## Vanguard DCC SIMM Hardware Advisory Notice

Vanguard 6435/6455

### Vanguard DCC SIMM Revision-A

T0001-39 A

**Figure 1. Removing the Data Compression/Encryption SIMM**

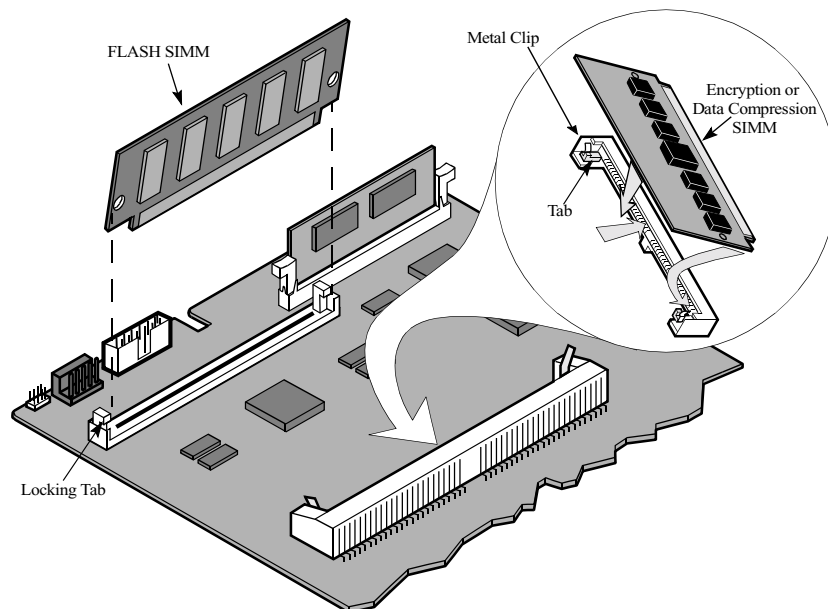
If the label MW1742 is affixed to the assembly, then the SIMM is equivalent to Revision-B, and no further action is required. Removal of the SIMM might be required to locate the label. See Figure 1 for SIMM removal information.
